Access Compliance Report

Public Rights-of-Way

(Curb Ramps)

Intersection ID: 10032717	Main Street: N_POPLAR_ST	Cross Street: N/A	Location: N
ADA ID: 51819FEE6D20	Ramp Type: Directional1	Initial Pass/Fail: Fail	Overall Compliance: No
Codes/Mitigation Info/Possible Solution		Field Measurements/Component Compliance	
Severity Score: 8.75

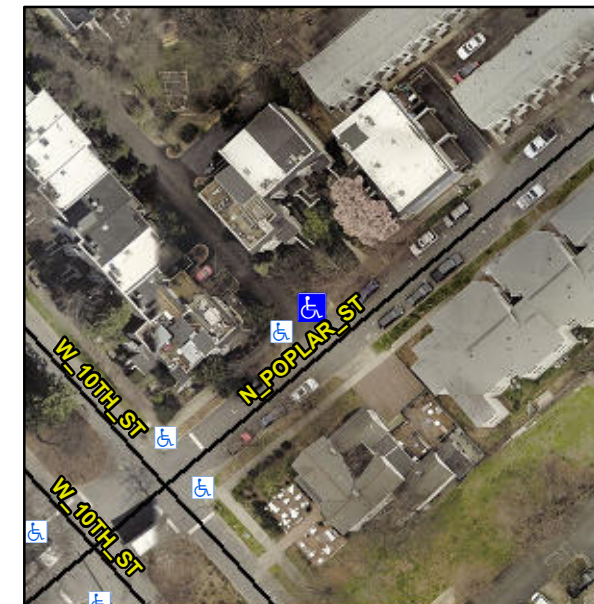
R304.5.1

Remove & Replace Entire Ramp.
